<b>DOCKETED</b>	
<b>Docket Number:</b>	23-OPT-01
<b>Project Title:</b>	Fountain Wind Project
<b>TN #:</b>	253509
<b>Document Title:</b>	FWP_NOP Comment Letter_Final_20231204
<b>Description:</b>	N/A
<b>Filer:</b>	Caitlin Barns
<b>Organization:</b>	Stantec Consulting Services, Inc.
<b>Submitter Role:</b>	Applicant Consultant
<b>Submission Date:</b>	12/4/2023 2:49:02 PM
<b>Docketed Date:</b>	12/4/2023

Re: Applicant's Comments to the Notice of Preparation of a Draft Environmental Impact Report for the Fountain Wind Project (23-OPT-01)

Figure 1: Distance Measurements between Above Ground Infrastructure

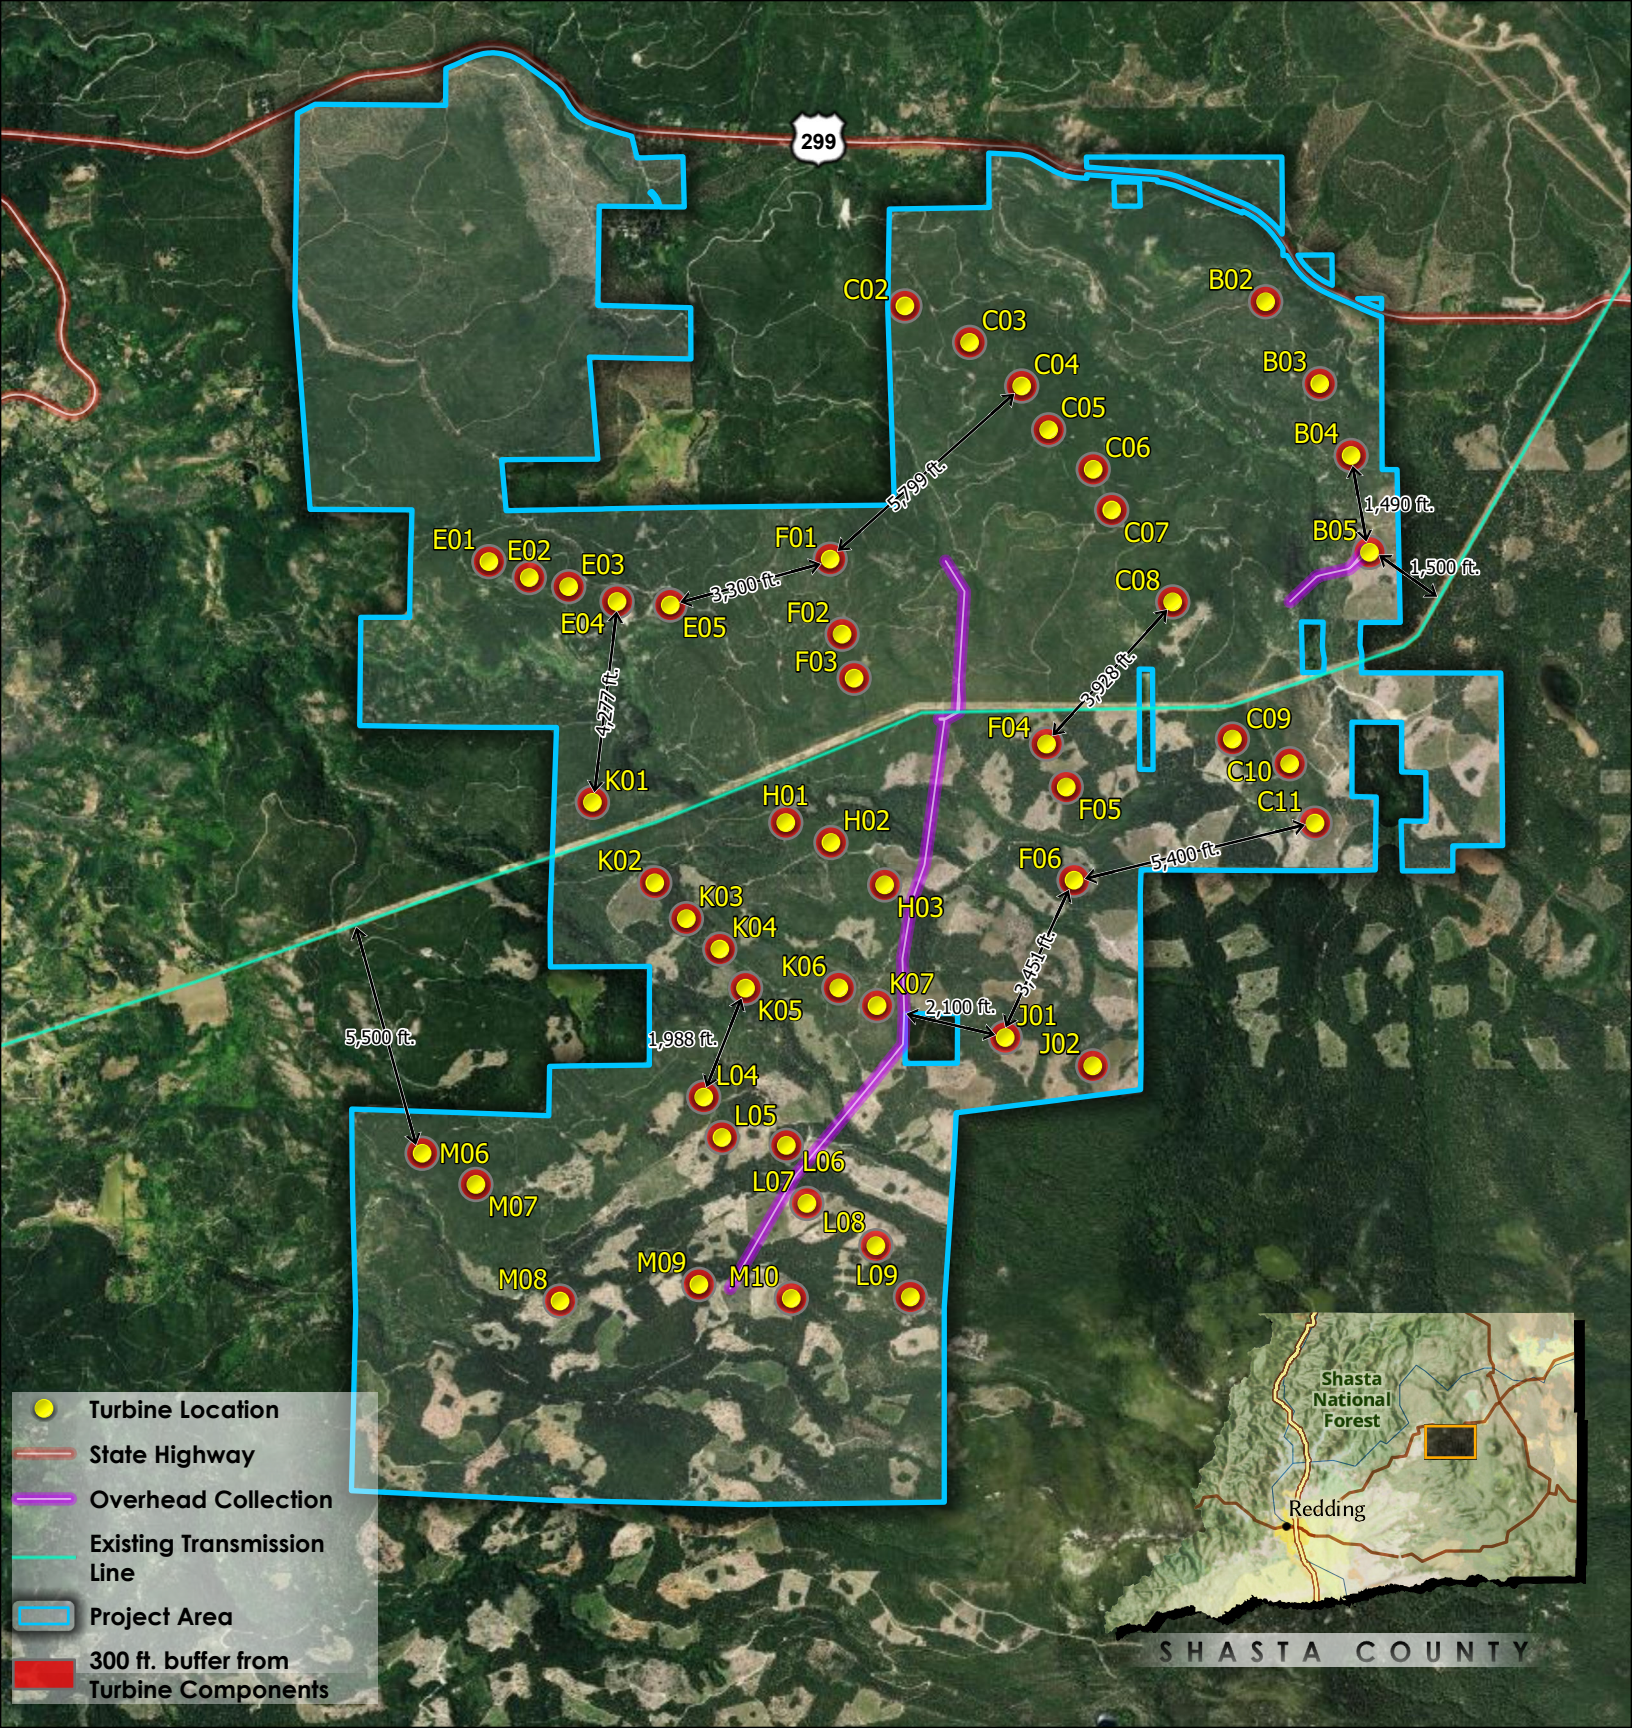
“...the project would introduce **significant** limitations on aerial firefighting abilities to aid in controlling and reducing the intensity of wildfires in the project area due to the spacing and height of the proposed remote turbines (over 600 feet tall)...” This statement is not consistent with previous and on-going consultations with the CAL FIRE Tactical Air Operations Unit, during which the Shasta County Fire Chief acknowledged that “aerial hazards do pose a safety concern for aerial firefighters; however, they are something we must work around on a daily basis.... Whether its power lines, antenna towers, windmills, cell towers or cable/wires spanning a drainage, the key to working in this environment is knowledge of their existence.” Wildfire experts have indicated that the presence of wind turbines does not preclude aerial firefighting because the turbines are aligned such that aircraft can operate between some of the turbine strings.

“With the project layout, **there are no clear straight paths** for firefighting planes to fly across/through the project area and aerial firefighting would be primarily limited to small areas along the edge of the project site and areas outside the perimeter of the project....CalFire does not fly aerial firefighting craft within a minimum of 500 feet vertically or horizontally of turbine structures; for safety, this minimum distance would be increased, **potentially significantly**, during fires based on site and fire conditions.” This conclusion is not supported by the evidence. There are, in fact, clear, straight paths for aerial firefighting within the project site while maintaining 500-foot vertical and horizontal clearance of turbines. Please see attached Figure 1 that shows distance between infrastructure within the project site that would allow adequate space and corridors for firefighting plane and helicopter maneuvers.
